City of Huron
Agenda for the Planning Commission/DRB
Wednesday, June 18, 2025 5:00pm.

TO: Chairman Boyle and Members of the Planning Commission and Design Review Board
FROM: Christine Gibboney, Planning & Zoning Manager
RE: 218 Cleveland d Road E (Berardi's)
DATE: June 18, 2025

TO: Chairman Boyle and Members of the Planning Commission
FROM: Alec Romick, Zoning Inspector
RE: 204 Rye Beach- Roof Mounted Solar Panels
DATE: June 18th, 2025

TO: Chairman Boyle and Members of the Planning Commission and Design Review Board
FROM: Christine Gibboney, Planning & Zoning Manager
RE: 720 River Road- Latanick Equipment- New Cold Storage Facility
DATE: June 18, 2025

Suncast Heavy Duty Resin Tremont
 Storage Shed

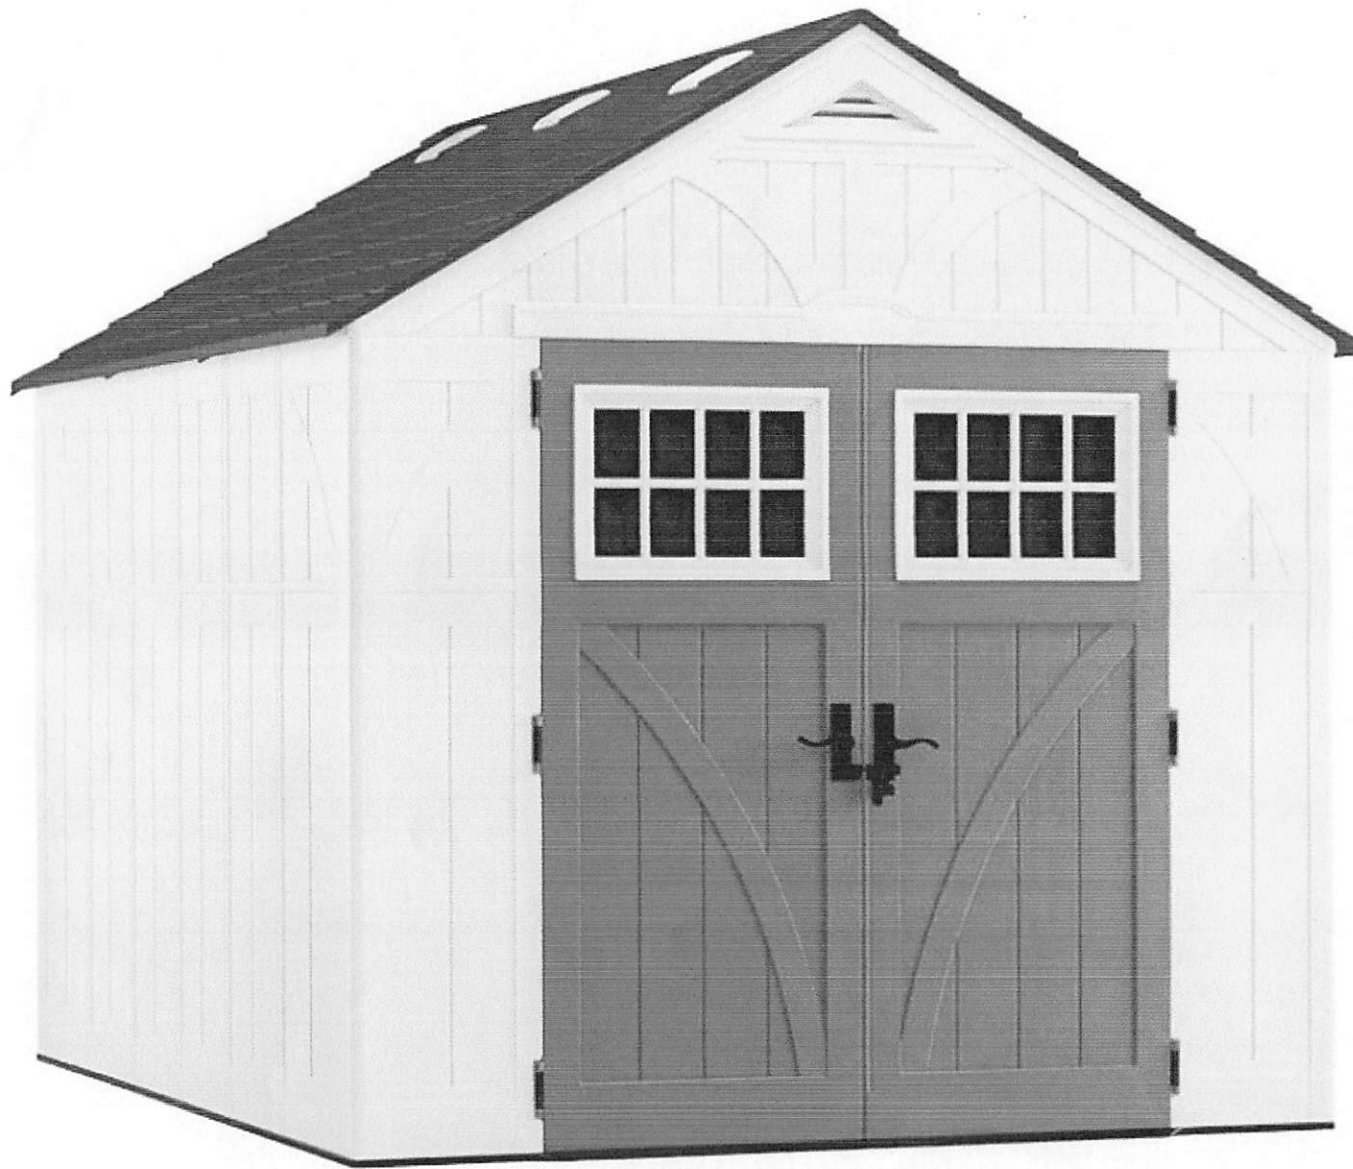
Applicant is proposing a 71sq. ft. resin shed to house the trash cart used to transfer trash to their dumpster. The location of the shed will be in a corner at the rear of the property. As proposed, it will not take away from any parking spaces and complies with the height regulations of accessory structures as it is under 15'. The applicant spoke to the Building Department regarding any distance requirements from the electrical unit.

Staff believes the shed will provide for the screening requirements of Section 1131.07 for this trash container and would recommend approval as proposed.

ROOF PLAN AND
MODULES

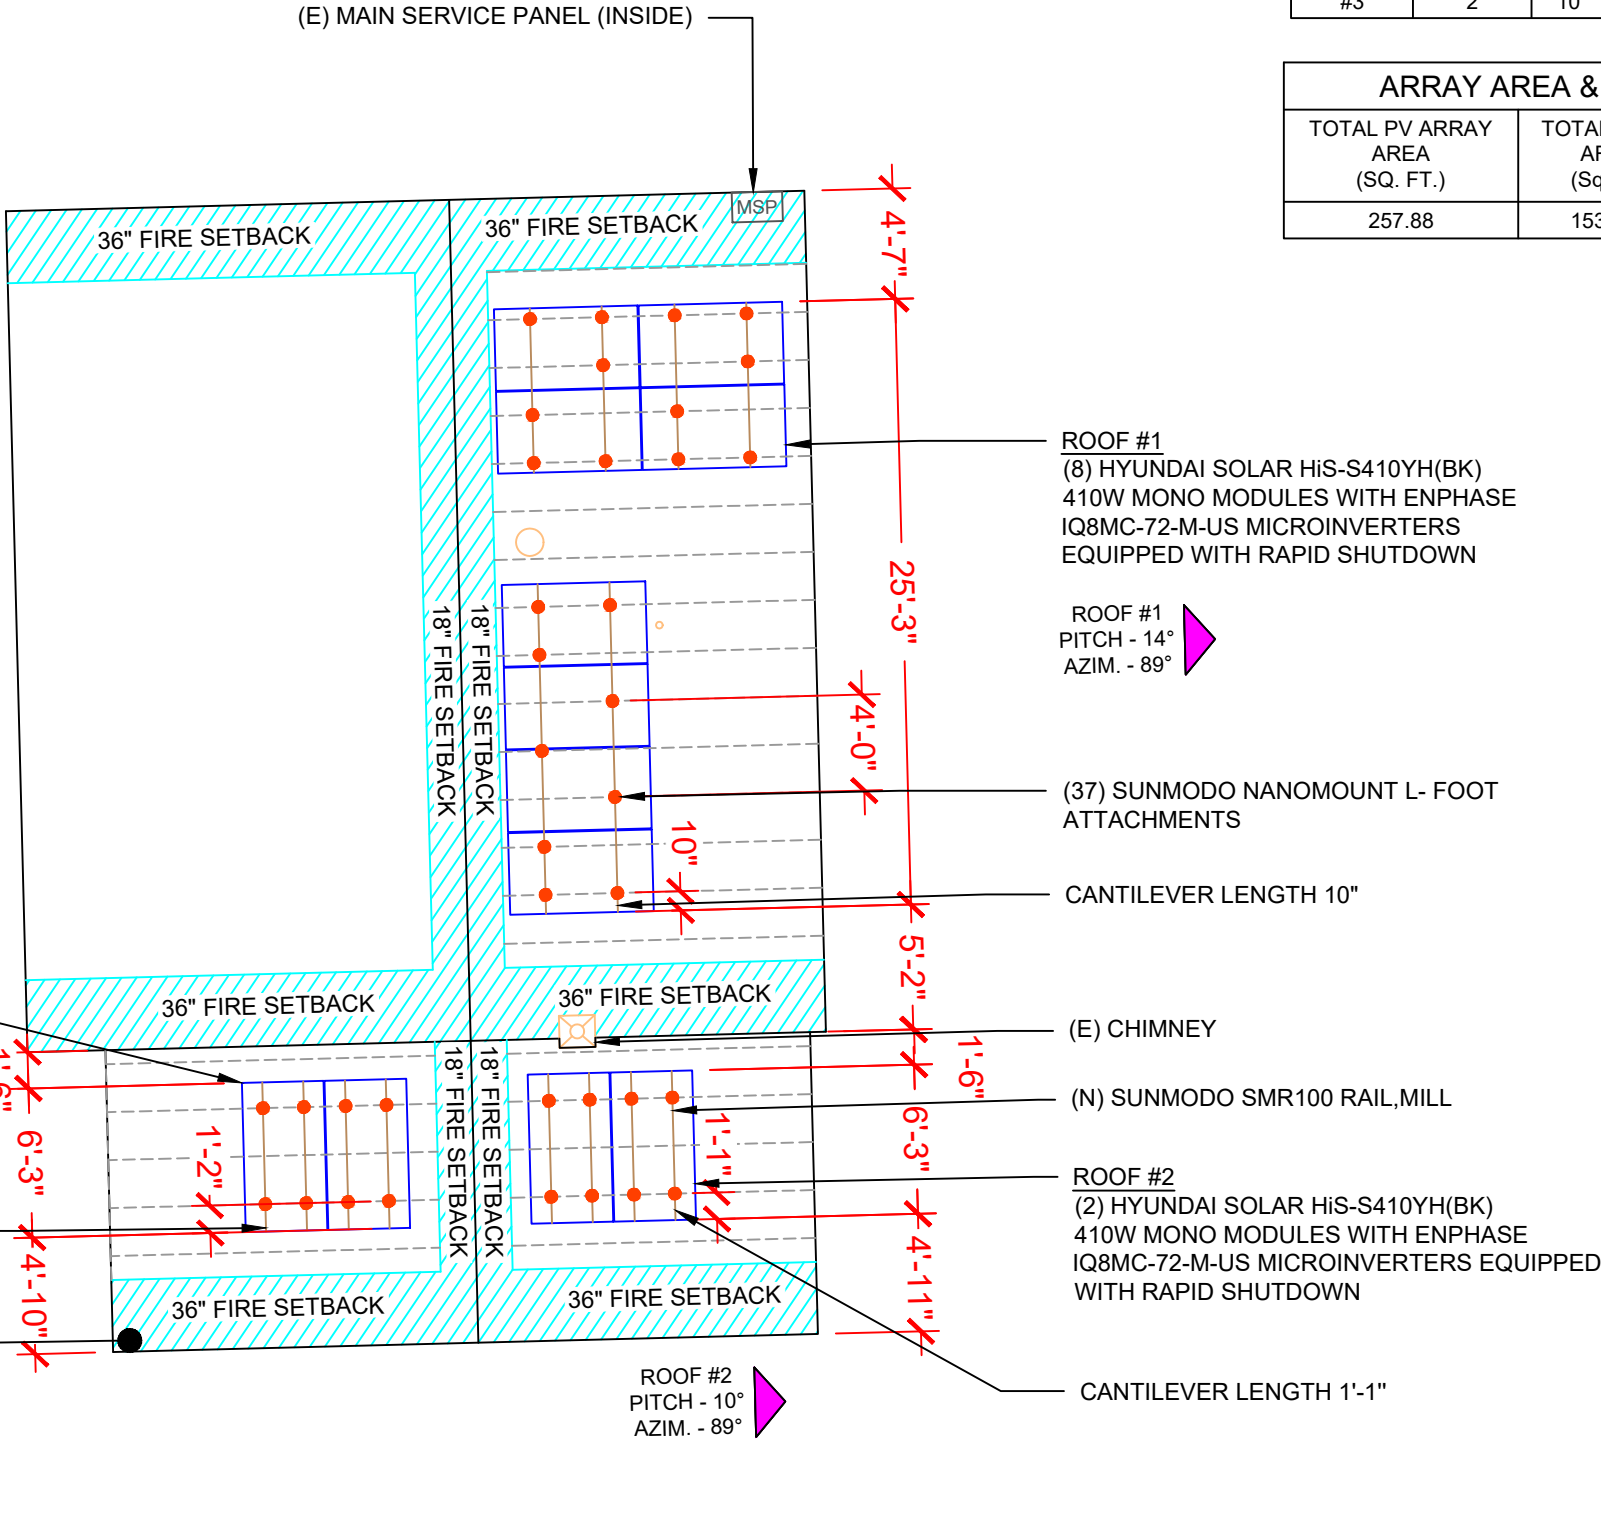
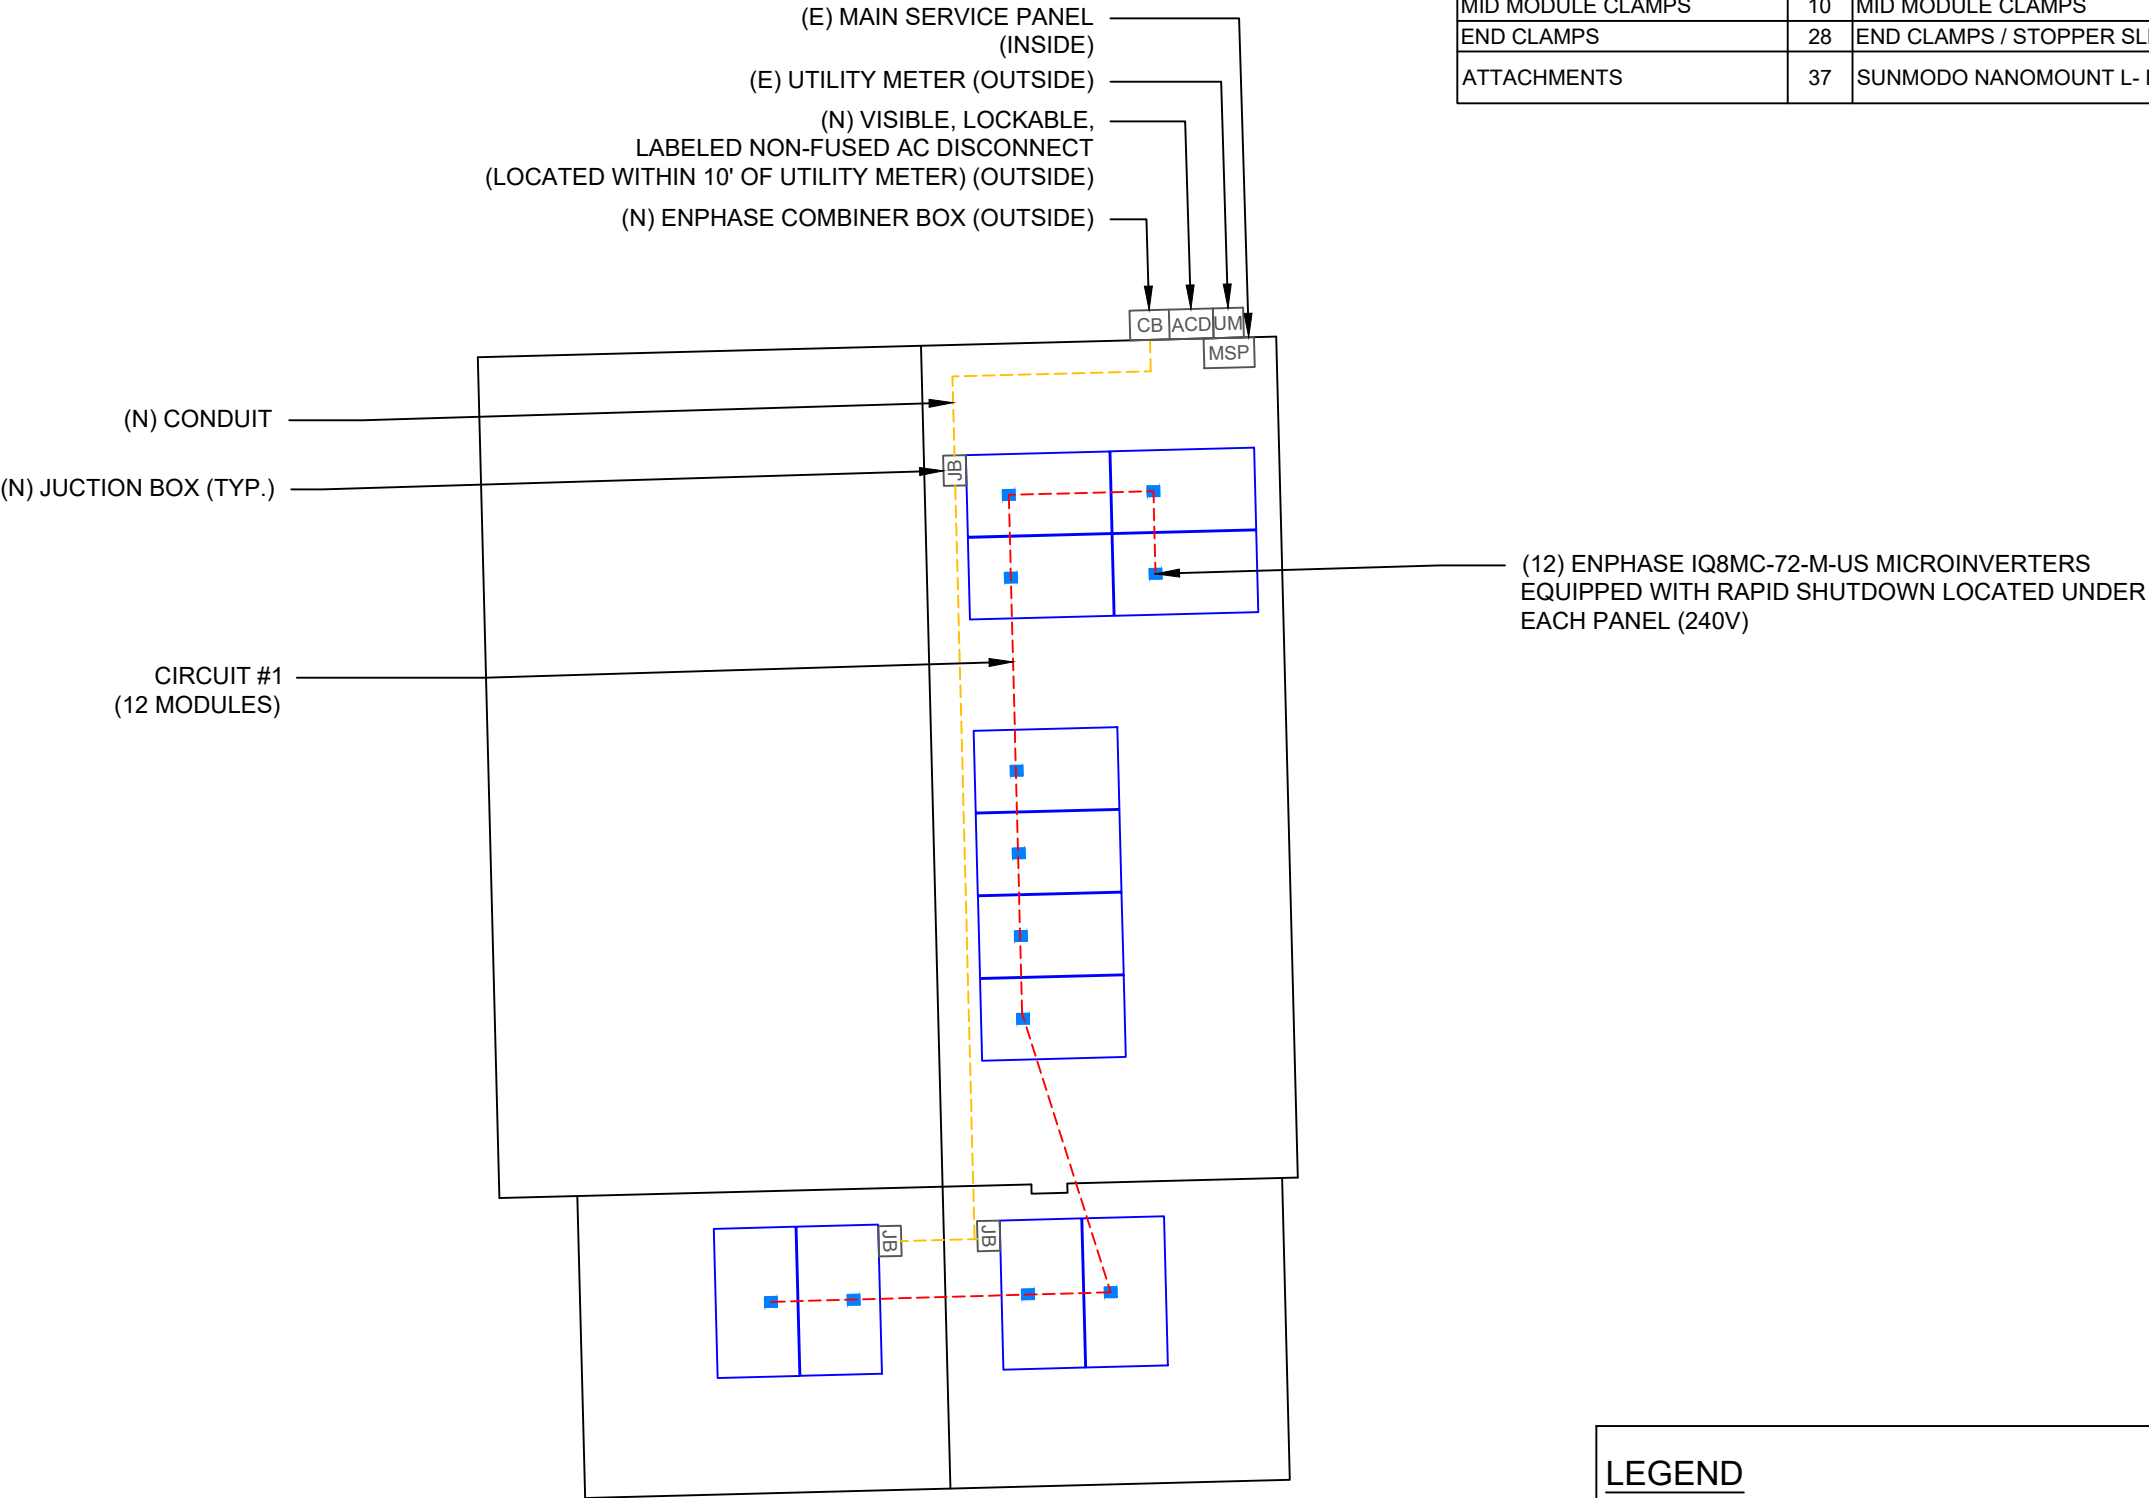
The proposed roof mounted solar panel system contains 12 panels, roof array area=257.88sq. ft. to be installed on the pitched roof of a single-story residential structure.

- The total roof area is 1535.96sq.ft.; roof area covered by the array is 16.85%.
- The panel attachment detail reflects a 6" rise from the roof to the top side of the panel (18" max per the code).
- The code requires that the system shall not be located within 12" of the edge of the roof, as proposed the system meets this requirement.
- The home is located within a neighborhood that has an HOA, however, the association is limited to the private park maintenance and use.

Upon approval from the DRB, the application will be submitted to the Building Department for the review and issuance of the Building Permit(s).
